NSLPP MEETING HELD ON 04/06/2025

ADDRESS/WARD: 20 Bay View Street, Lavender Bay

APPLICATION No: DA 275/24

PROPOSAL: Demolition of an existing dwelling and construction of a new dwelling

Figure 19: Extract of proposed Long Section containing height measurements

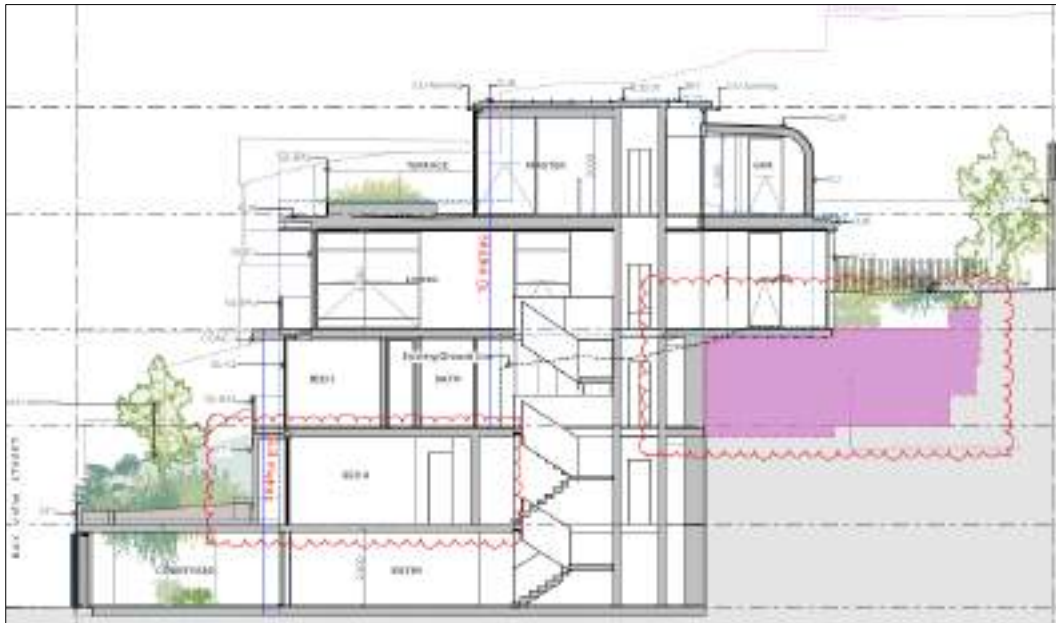
A written request provided by AK Planning on 26 August 2024 was submitted as part of the application. The written request acknowledges the departure from the development standard of 1.5m (17.6%).

Figure 21: Maximum excavation proposed on site is 8.4m (marked as blue line) for the lift and vapour cavity

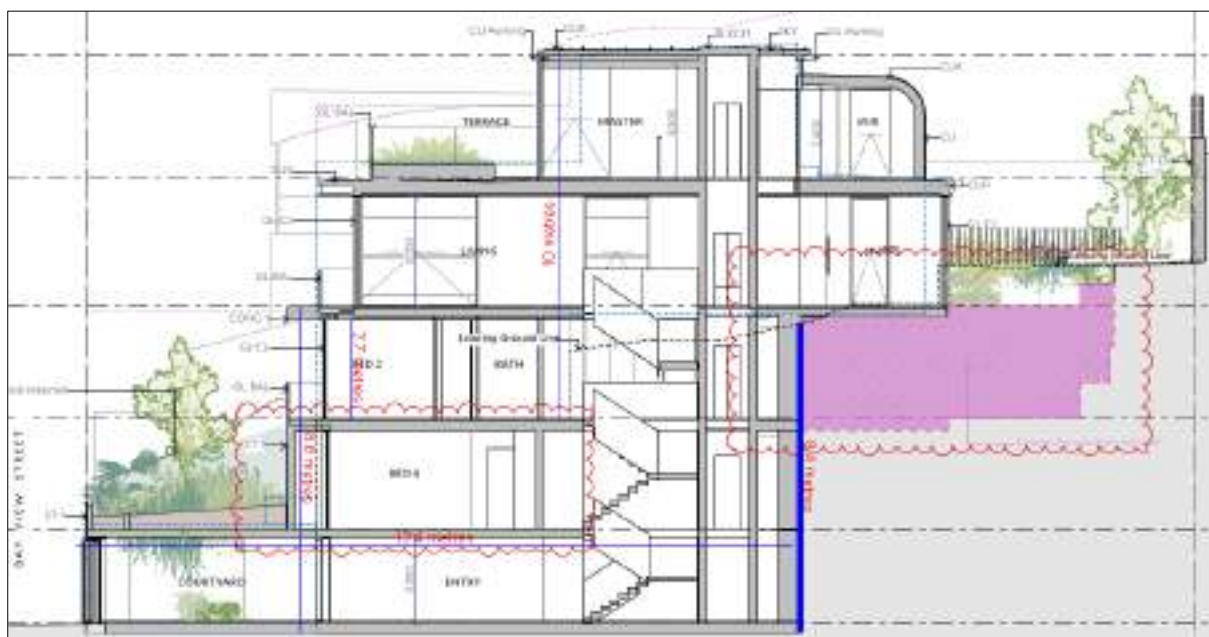
Excavation up to 8.4m is proposed to accommodate for the lift and facilities within the proposed Basement Level (Refer to Figure 21). Excavation is not uncommon for properties on the high side of Bay View Street to create basement/garages and lifts under and through dwellings due to the steep topography.

Figure 52: Proposed view from First Floor Kitchen/Dining Room (Source: Applicant's SEE)

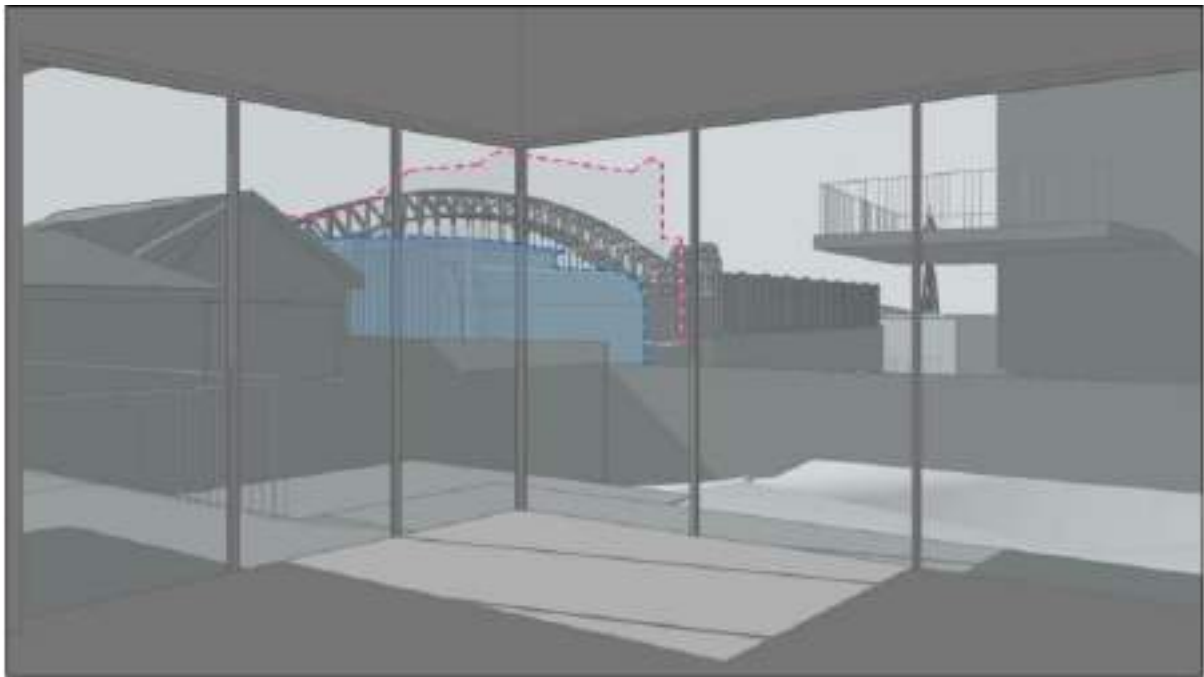
Based on the CGI above, the proposed WIR obstructs the deck of the Harbour Bridge where it would not have as existing. The proposed WIR roof ridge has an RL31.6 sloping down while the existing roof at this location is approximately RL25.21-25.28. The deck is one of the key elements of the Sydney Harbour Bridge and the obstruction of the connection at the corner of the arch and the deck highlighted in yellow (Figure 52A below) is significant in the composition and presence of the iconic view in a visual setting.

Figure 1: Delete portion of WIR and bathroom as shaded in grey

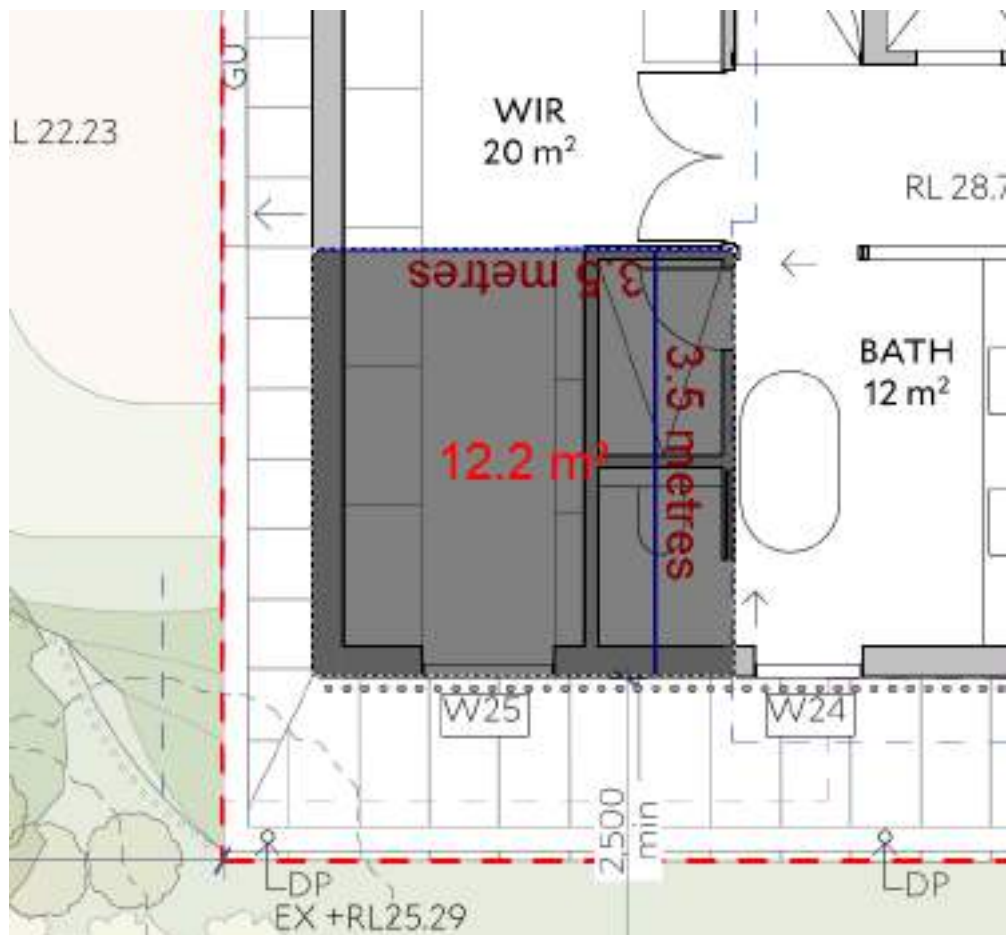
A5. The setback of the WIR on the master bed level is to be increased by 3.5m along both the southern and western elevations as identified in **Figure 1** below. The grey area in Figure 1 is to be deleted and must not be reconfigured or converted into usable GFA due to the view corridor.

(Reason: To ensure the composition of iconic view of the Sydney Harbour Bridge is protected for 19 King George Street; To ensure view sharing in accordance with *NSLEP 2013* and *NSDCP 2013*)
